PARTS & SERVICE NEWS

REF NO.	AT04089
DATE	Apr. 21, 2004

SUBJECT: MODIFICATION PROCEDURE FOR HOIST CONTROL VALVE ON HM300-1

APPLICATION: HM300-1 Articulated Dump Trucks, Serial Nos. 1001 thru 1023

Fig. 1

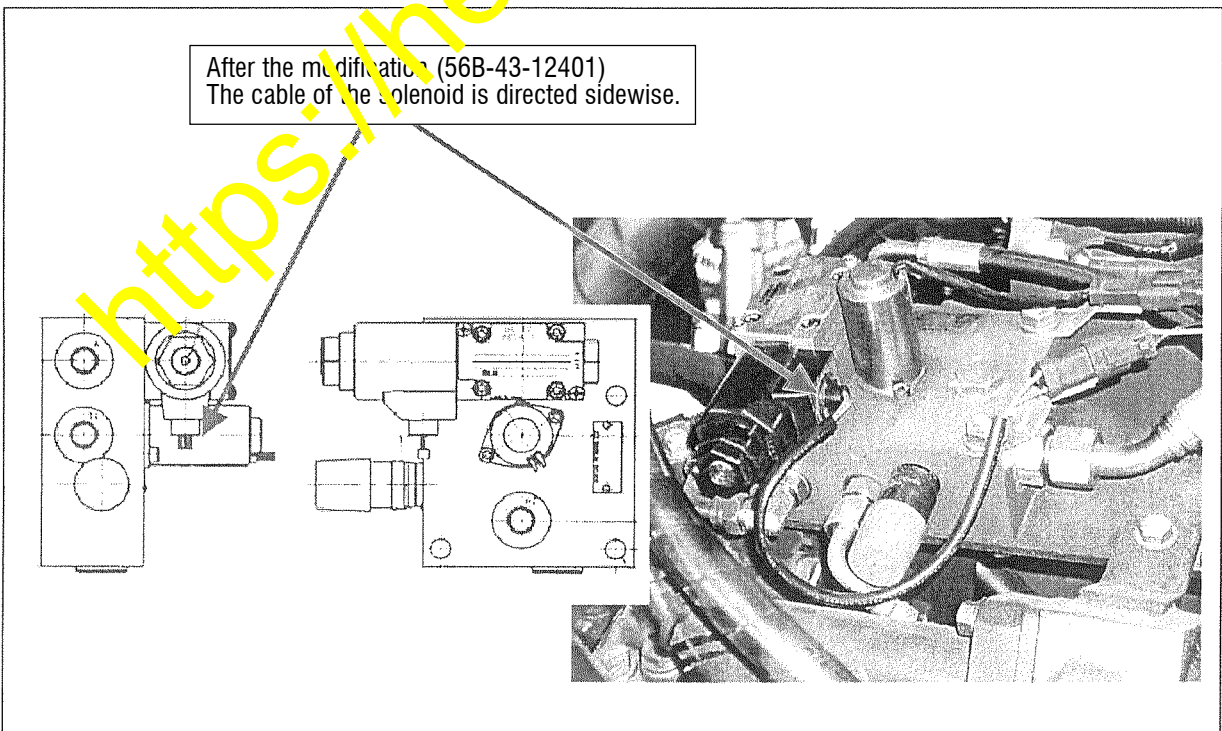
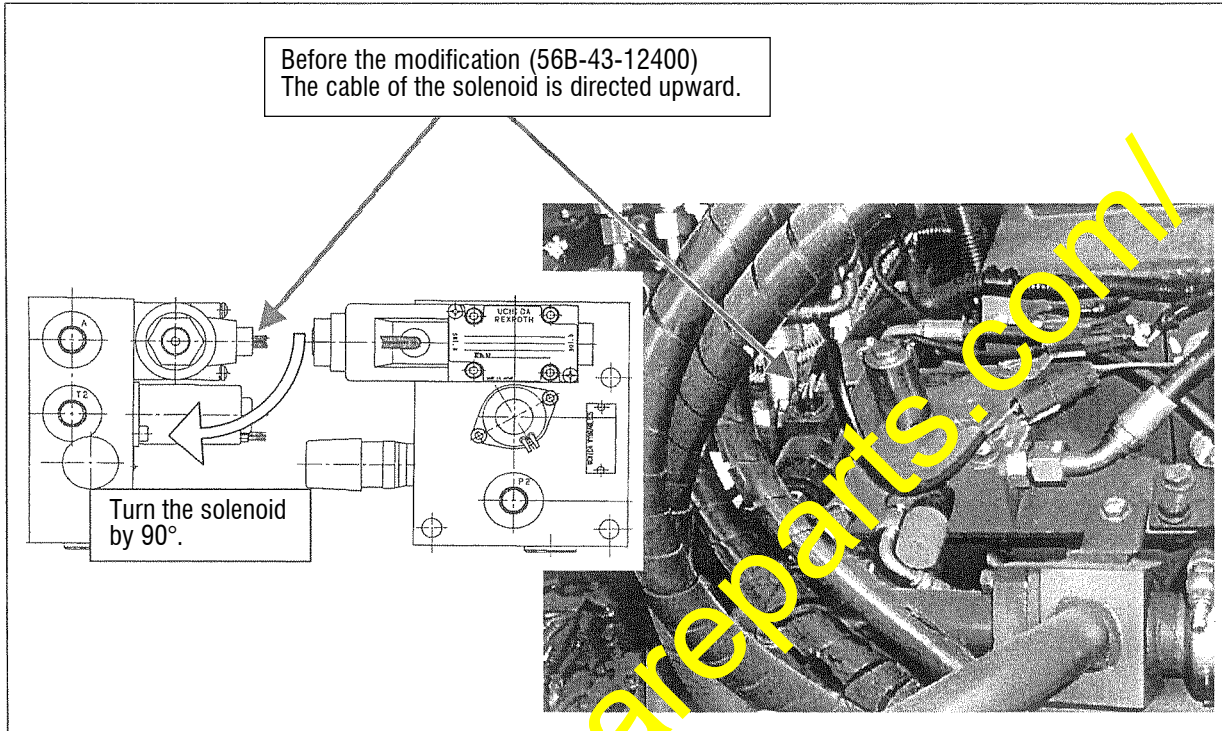
Regarding the mounting direction of the solenoid of the hoist control valve on the HM300-1 articulated dump trucks, when the cable is directed upward, interference may occur between the cable and the heater hose.

To avoid the interference between the cable of the solenoid of the hoist control valve and the heater hose, change the mounting direction of the solenoid turning it by 90° as seen in the pictures below.

Therefore, change the mounting direction of the solenoid following the modification procedure described in this Service News to prevent the occurrence of the above mentioned interference.

Fig. 3

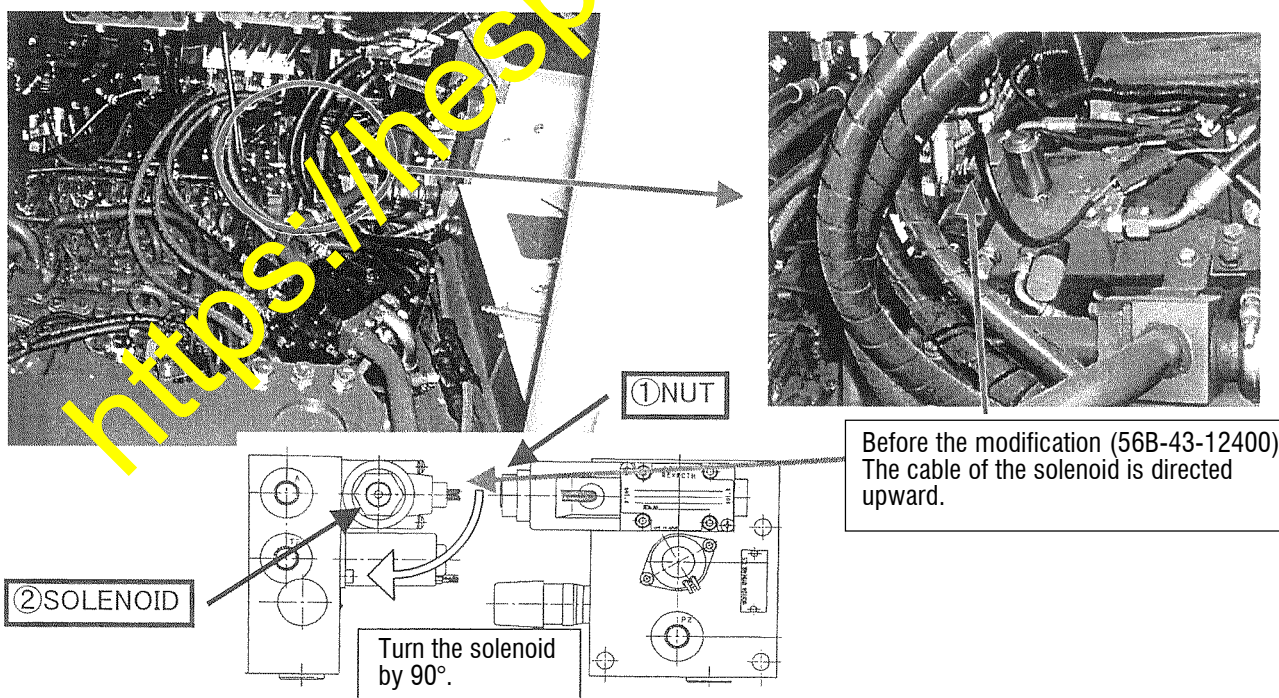
- (1) Remove the nut ①.
- (2) Turn the solenoid ② by 90° to change its mounting direction from upward to side-wise.

Before turning the solenoid ②, pull it out by 20 mm or more. After that, turn the solenoid by 90°.

Fig. 4

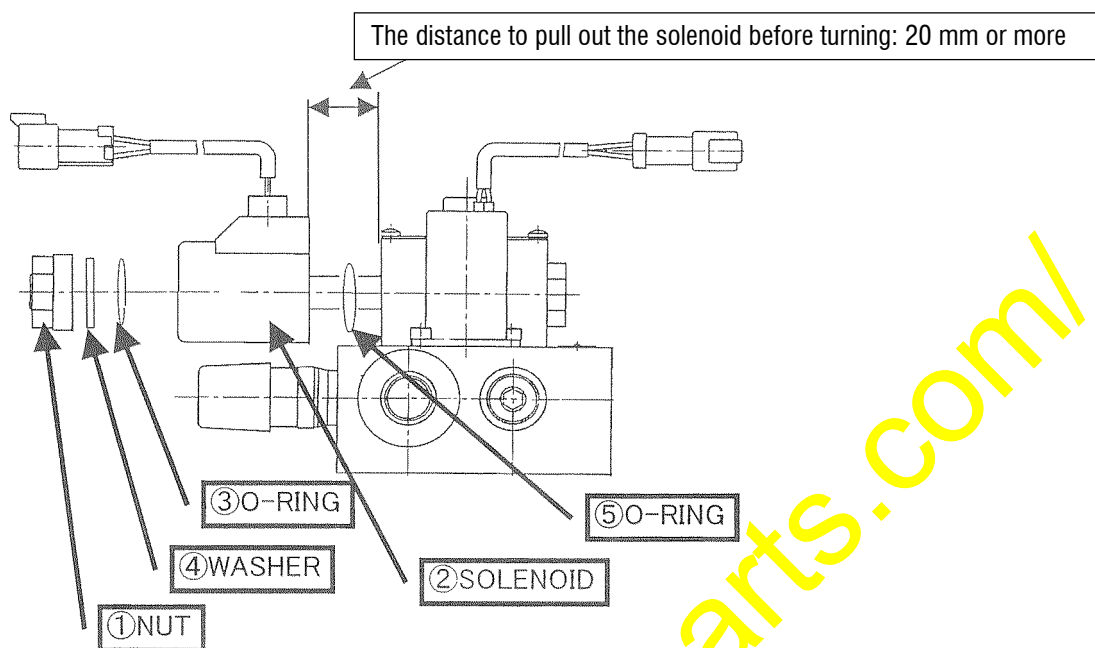
Be careful not to lose the O-rings ③ and ⑤, and the washer ④.

(3) Install the solenoid ②, O-rings ③ and ⑤ and washer ④. Tighten them using the nut ①.

(Tightening torque for the nut: 3.42 - 4.91 Nm {0.4 - 0.5 kgm})

Fig. 5

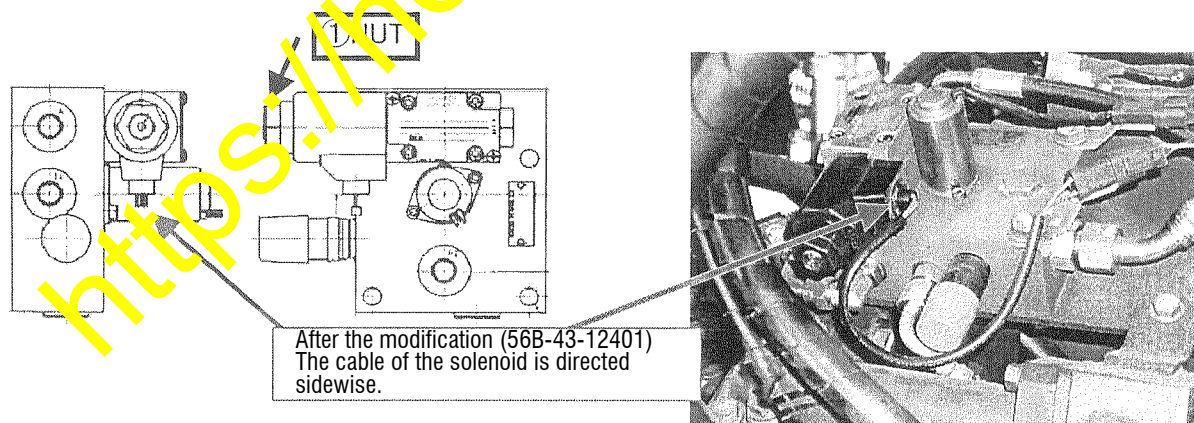
Carry out the above installation work carefully with the O-rings ③ and ⑤ not dislocated nor pinched.
